MURPHY CREEK - ZANTE STREET

AURORA, COLORADO

INFRASTRUCTURE SITE PLAN

EXISTING DRAINAGE PLAN 2

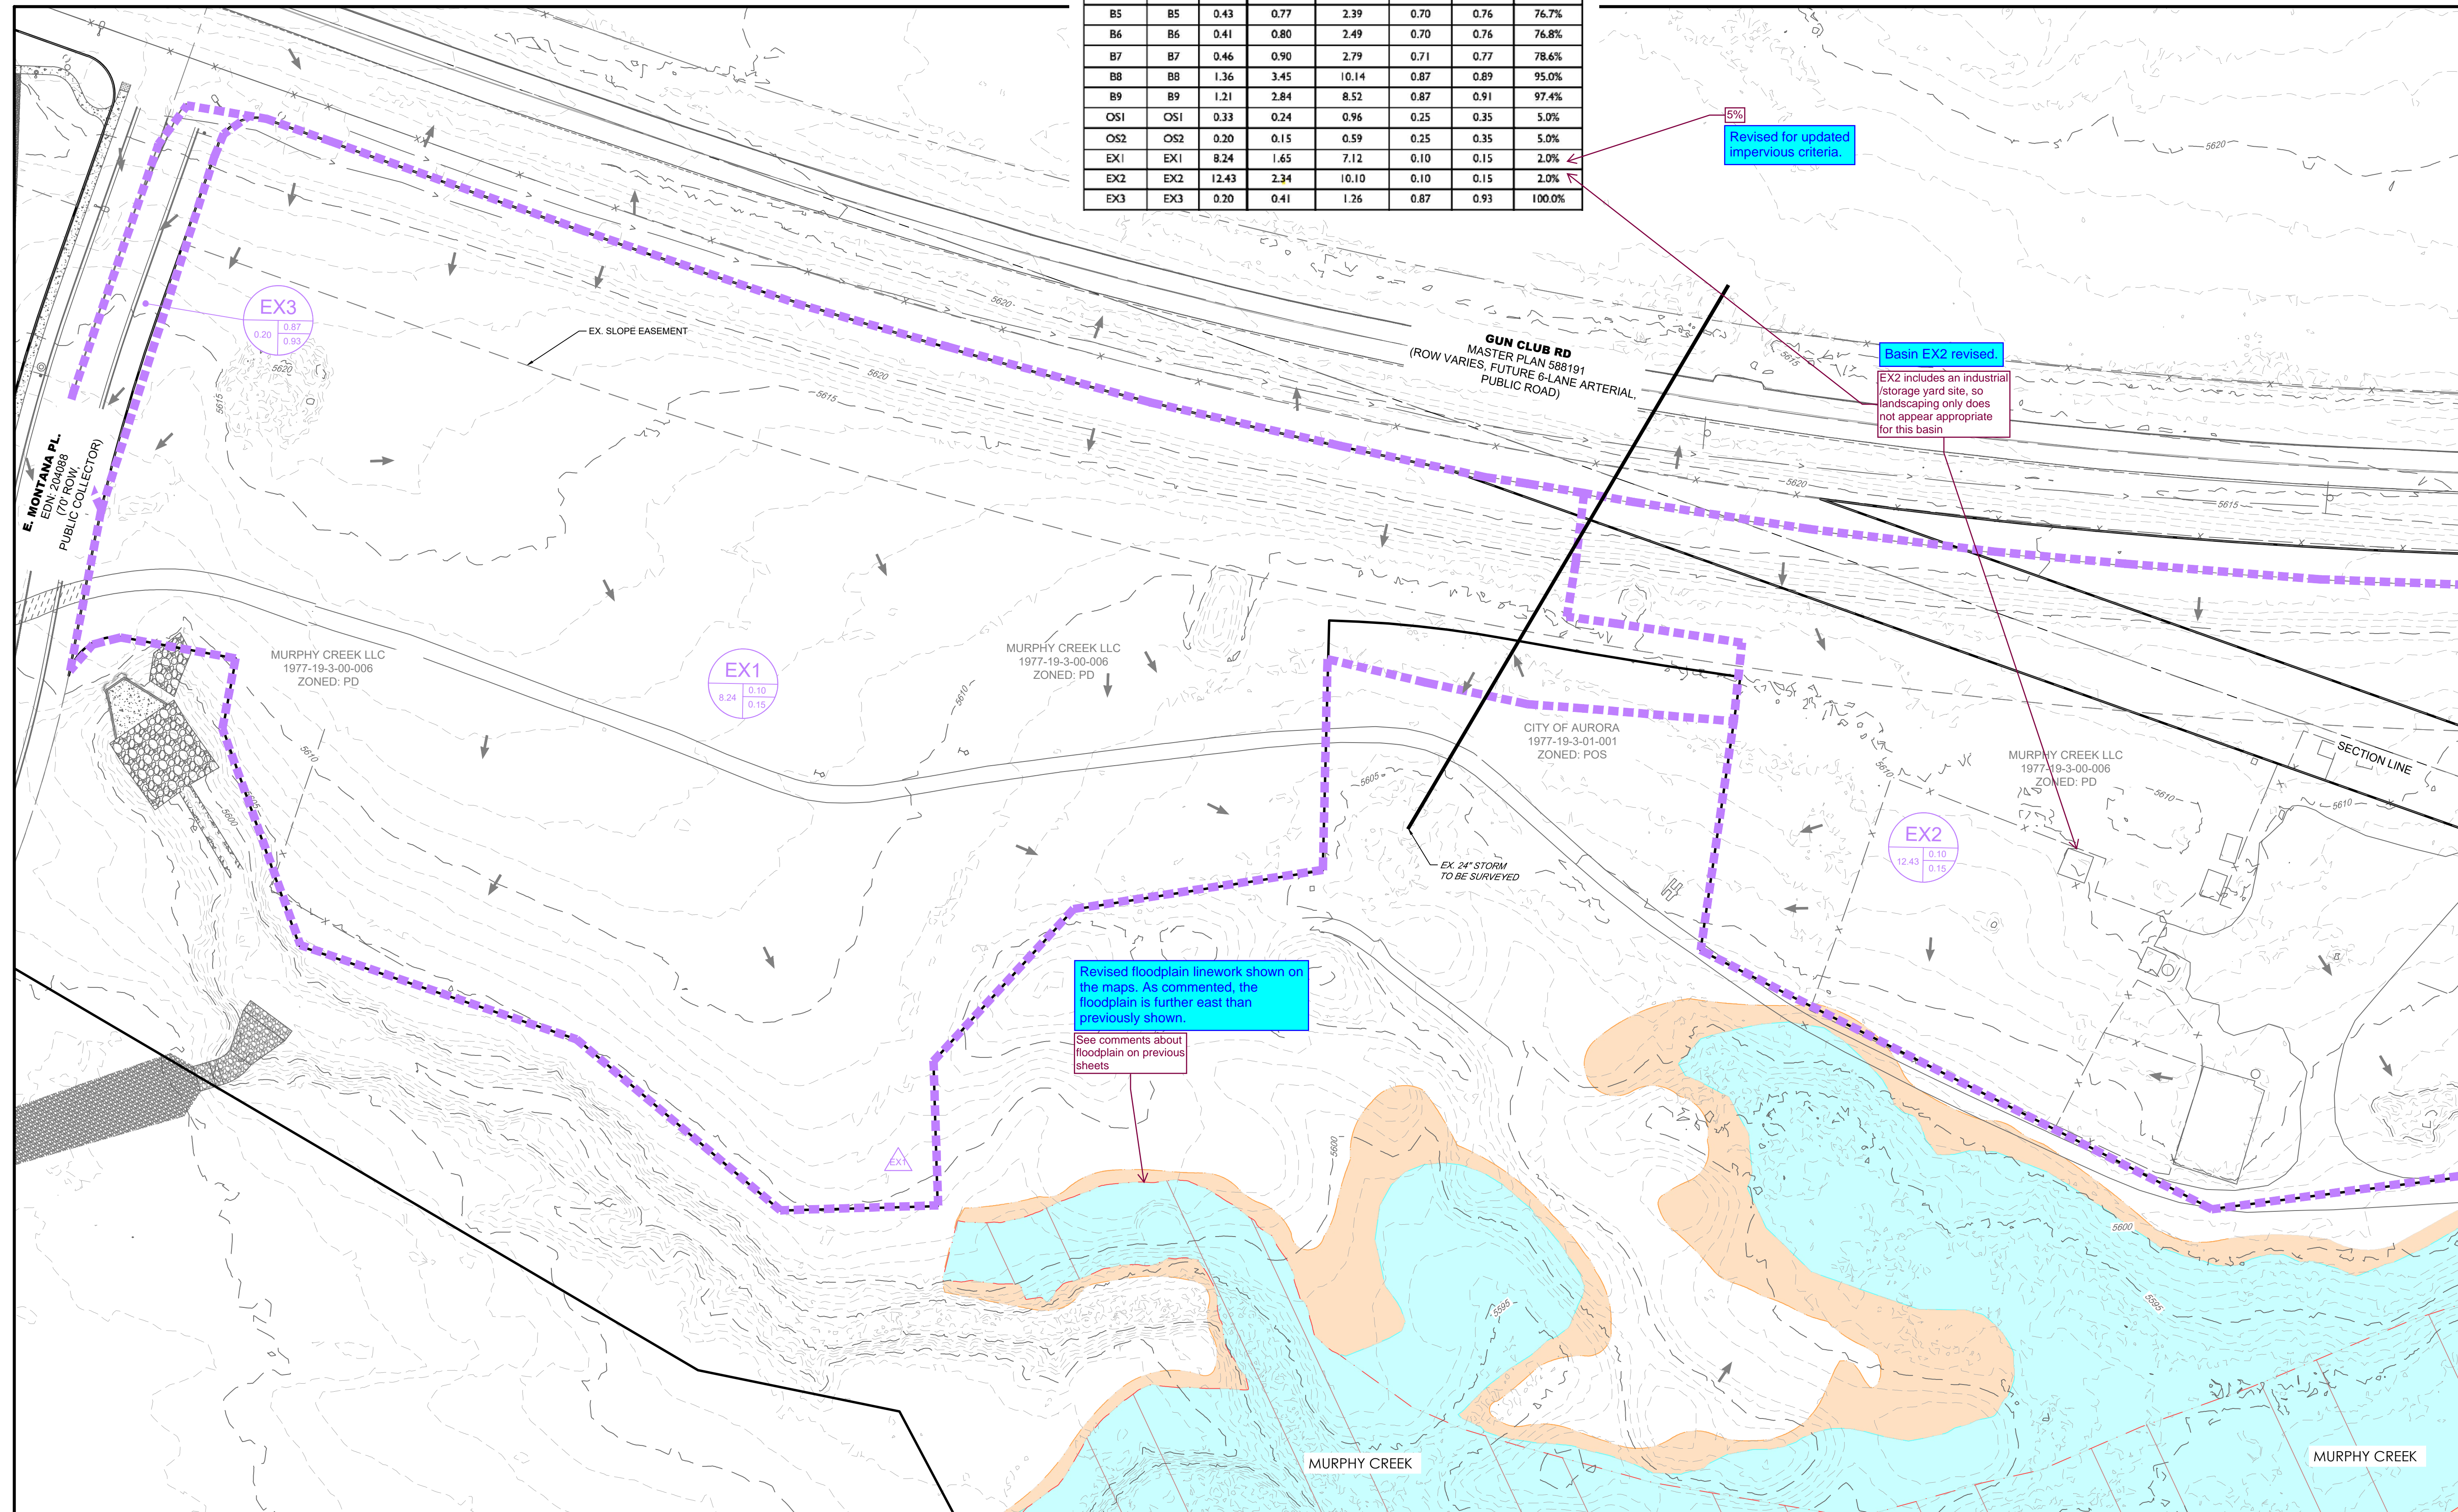
Remove

Existing basin sheets should be sized to 11x17 and placed in the report/letter

Basin boundary revised.  
Appears part of this basin  
flows to the north

Existing drainage maps have been sized correctly and included in the PDR.

Existing drainage maps have been sized correctly and included in the PDR.
